HISTORIC AND DESIGN REVIEW COMMISSION

HDRC CASE NO: 2020-470
ADDRESS: 2300 BROADWAY
LEGAL DESCRIPTION: NCB 3857 BLK LOT 9 EXC NE IRR 15FT
ZONING: I-1, RIO-1
CITY COUNCIL DIST.: 2
APPLICANT: Cheryl Cole/Dallenbach-Cole Architecture
OWNER: Robert Fisher/SOVRAN ACQUISITION LTD PARTNERSHIP
TYPE OF WORK: New construction, final approval
APPLICATION RECEIVED: February 10, 2021
60-DAY REVIEW: Not applicable due to City Council Emergency Orders
CASE MANAGER: Edward Hall

REQUEST:

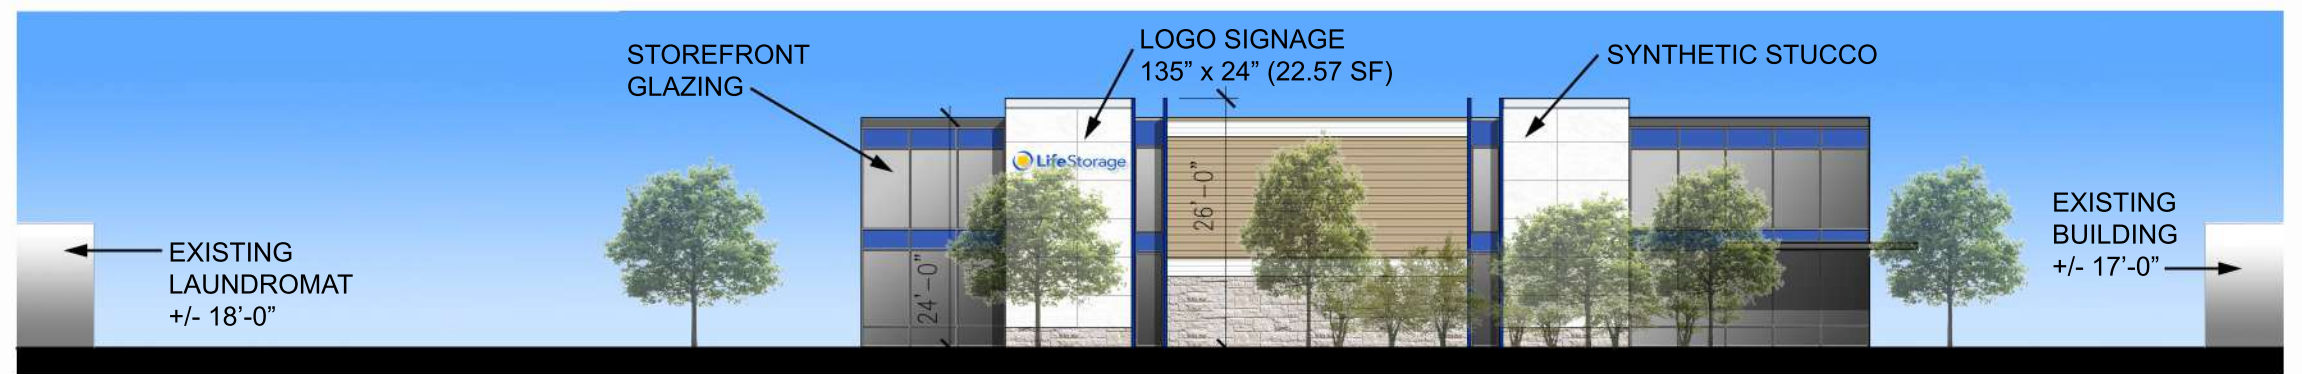
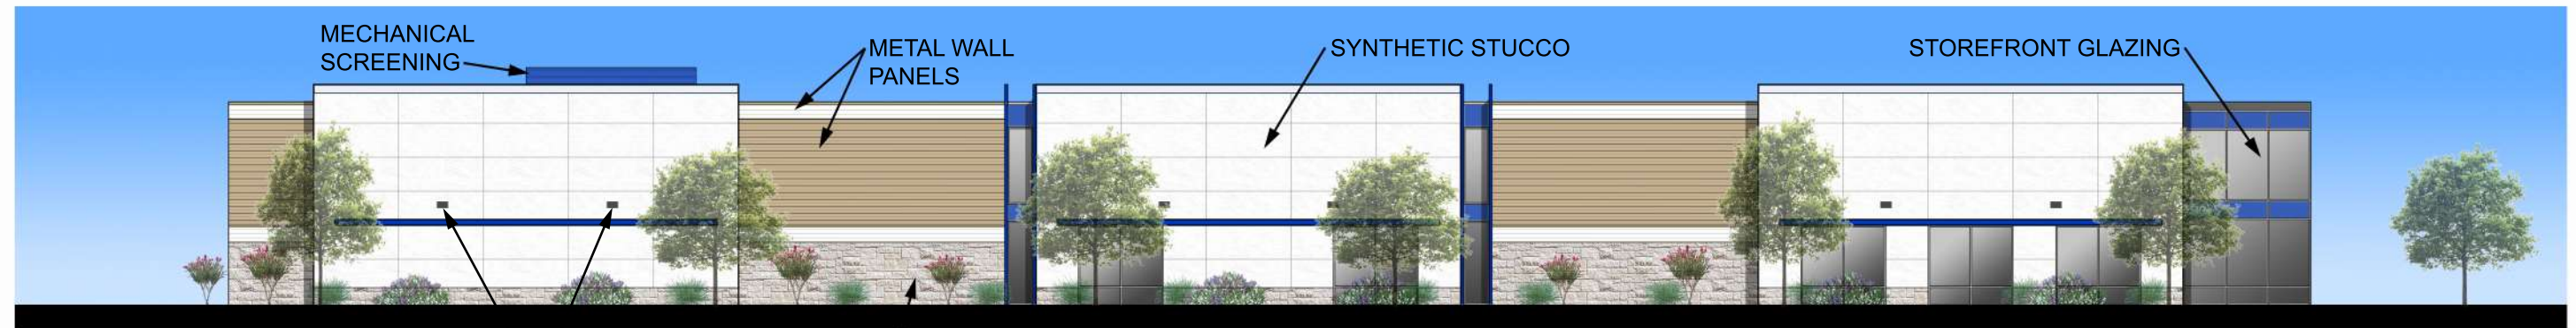
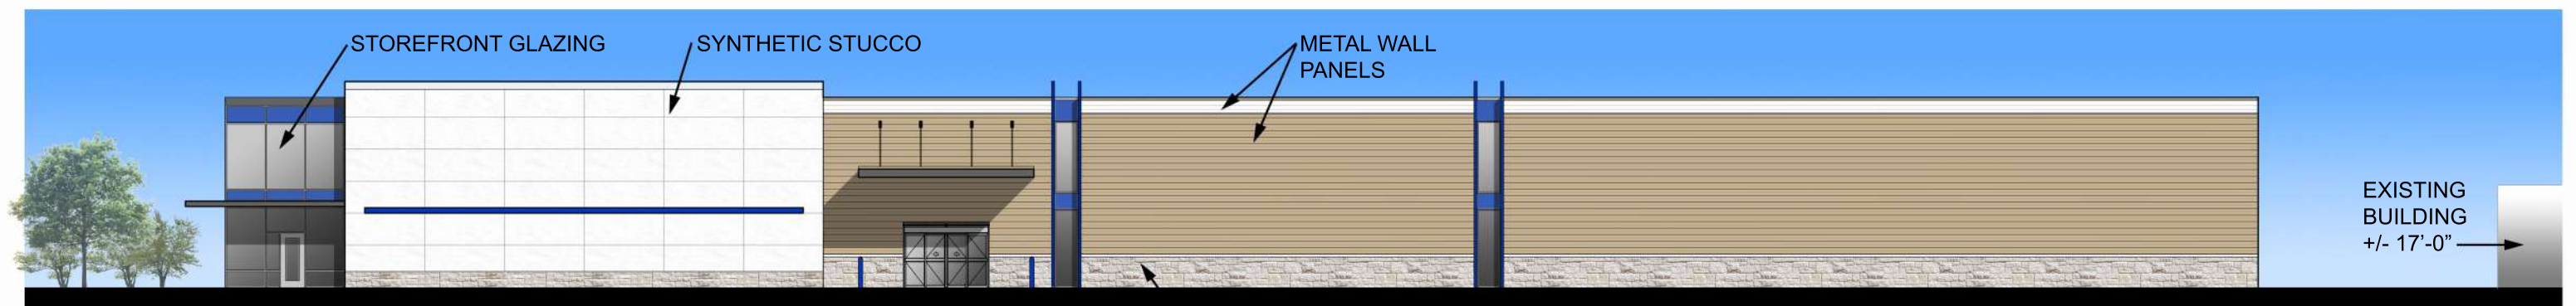
- i. That the applicant continue to study ways to incorporate additional human scaled elements and façade separating elements into the street facing facades. **The applicant has added additional door openings to the north and east facades.**
